# Planning and Zoning Commission

Thursday, January 9, 2025

## Bridge Park, Block Y 24-154CP

### Case Summary

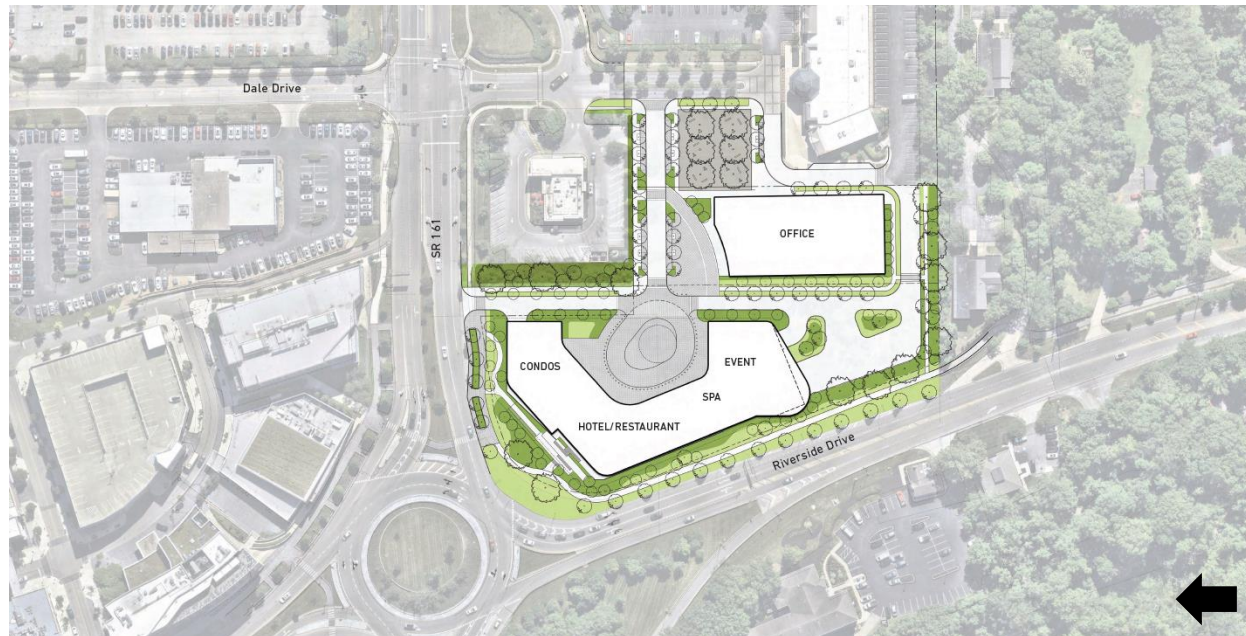
The site's layout is generally similar to the informal review application in 2022, with the mixed-use building in the northwest corner of the site adjacent to the roundabout. The proposed office building is shown in the southeast corner of the development, replacing the existing commercial building on the site. A drop-off area is provided for the hotel and event space in the courtyard east of the mixed-use building. Drive aisles are located to the side and rear of the mixed-use

Vehicular access is primarily provided from Dale Drive to the east of the site. The applicant proposes an additional access point along W. Dublin-Granville Road to the northeast of the mixed-use building. This access point is expected to be a right-out only, prohibiting access from eastbound traffic on W. Dublin-Granville Road. Per the Code, access onto a principal frontage

street is not permitted unless determined otherwise by the City Engineer. Staff will continue to review the proposed access to determine whether it is appropriate for the site's development. The applicant should continue to work with Staff to develop the street network and determine the appropriateness of the access point along W. Dublin-Granville Road.

The development will also improve pedestrian circulation throughout the site and along Riverside Drive and W. Dublin-Granville Road. The applicant proposes shared-use paths along both frontages, with sidewalks internal to the site connecting to Dale Drive and the adjacent properties to the east. Staff is working through the East Bridge Street Corridor Vision Study to coordinate improvements to W. Dublin-Granville Road to encourage pedestrian activity. Similar emphasis should be placed on the Riverside Drive frontage. The applicant should continue to work with Staff to develop the design of both the W. Dublin-Granville Road and Riverside Drive streetscapes and how this will integrate with the proposed development.

- 3) The applicant continue to work with Staff to continue to develop the street network and determine the appropriateness of the access point along W. Dublin-Granville Road;

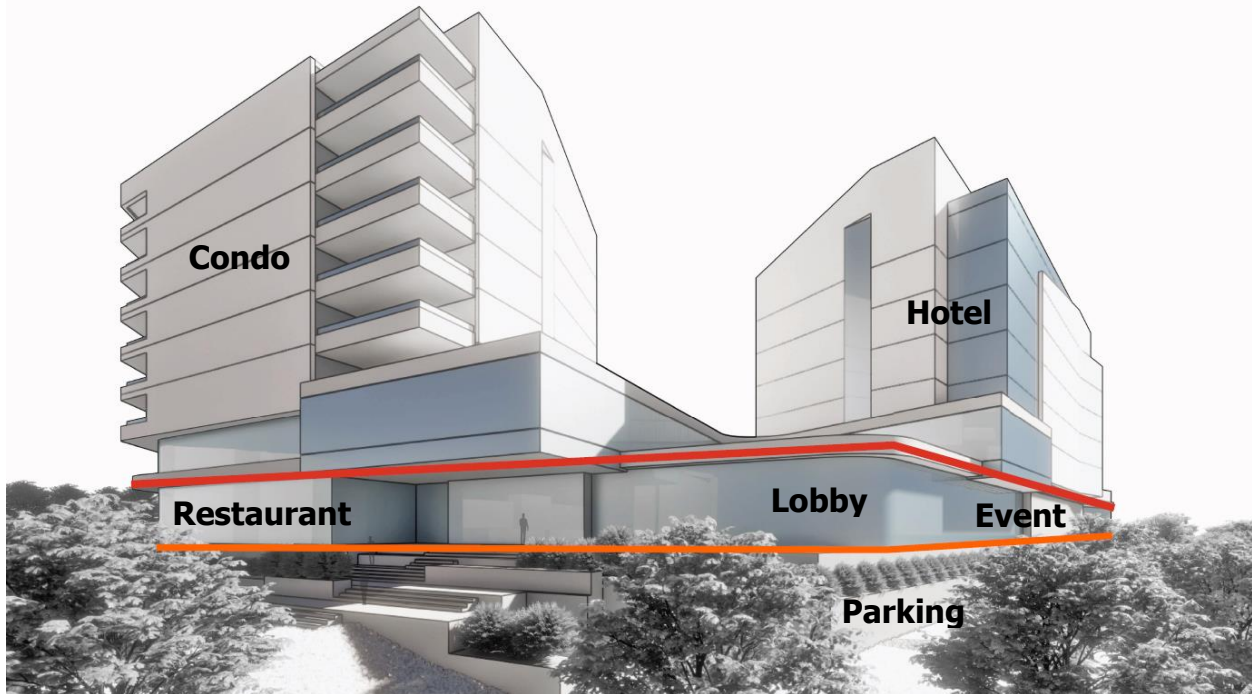
### Podium Parking Structure

The base of the building is three stories of podium parking area. This area is represented below the orange line in the image above. This portion of the structure is partially exposed along Riverside Drive, as the lower two parking levels are underground parking hidden from the street. These levels are not visible east of the building due to the positive grade change. Location requirements for podium parking are determined by the building type of the structure. Parking decks are generally required to be located to the rear of the first three floors of a building and fully in any basement.

The first full floor of the building (the space between the orange and red lines in the image above) contains two restaurants, an event space, and a hotel lobby area. This space is oriented toward the public street frontages, and significant amounts of glass are expected. This space is intended to have an entrance in the northwest corner of the building and access to the courtyard drop-off area to the rear of the building.

The 26-unit condominium tower is a part of the northern portion of the building. This tower is 8 stories tall, as measured from the base of the first full story. From the lowest point of the site, the tower is 126 feet in height. This tower will be oriented towards W. Dublin-Granville Road with balconies in the northeast and northwest corners of each floor. The applicant intends to utilize a mix of stone, masonry, metal, curtainwall glazing and other materials consistent with the Bridge Park development throughout the building.

The 130-unit hotel tower is a part of the southern portion of the building. This tower is 7 stories tall, as measured from the base of the first full story. From the lowest point of the site, the tower is approximately 116 feet tall. This tower will be oriented towards Riverside Drive to the west. The applicant intends to use materials consistent with the condominium tower to provide consistency throughout the development.

- 6) The applicant works with Staff on the determination of building types and how they relate to the design of the buildings; and,
- 7) The applicant continues to work with Staff to determine the necessary site improvements to meet the stormwater management requirements for both the proposed development and the Shoppes at River Ridge.

### Massing Comparisons

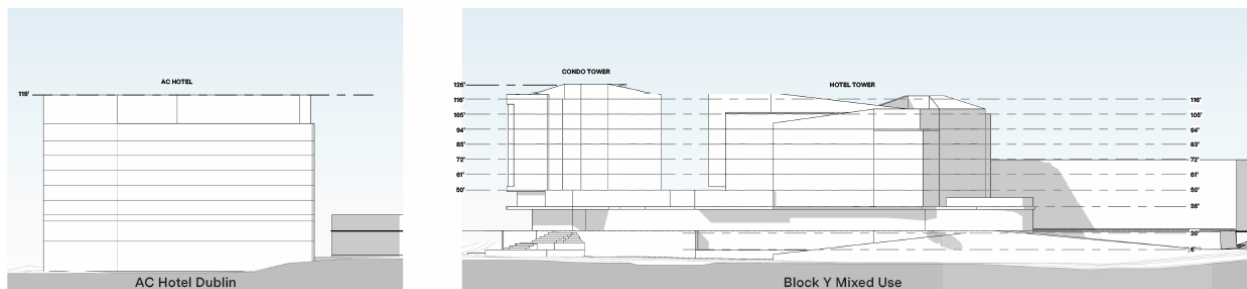
Shown below is a comparison of massing along Riverside Drive between the Block Y development and the AC Hotel, which was constructed with Block A in 2015. The AC Hotel was approved as a Corridor building type with waivers at a height of 119 feet across 8 stories. The proposed Block Y condominium tower is approximately 7 feet taller than the AC Hotel. The massing of the proposed building is broken up by varying tower heights and uses throughout different portions of the building. Additionally, the height of the building decreases towards the southern property line.

It is anticipated that waivers will be required for both the condominium and hotel portions of the building. Waiver applications are anticipated with the development of Bridge Street. They are intended to give developments greater flexibility to provide a high-quality design that aligns with the goals and intent of the Bridge Street District. The applicant must provide reasoning for any waiver requests with a subsequent application.

**Criteria Met with Conditions.** The current proposal is likely to require waivers to the height of the mixed-use building. Subsequent applications will require additional analysis to review the additional height requests. However, the general scale of the development is complementary to the Bridge Park development to the north. The applicant should work with Staff on the determination of building types and how they relate to the design of the buildings.
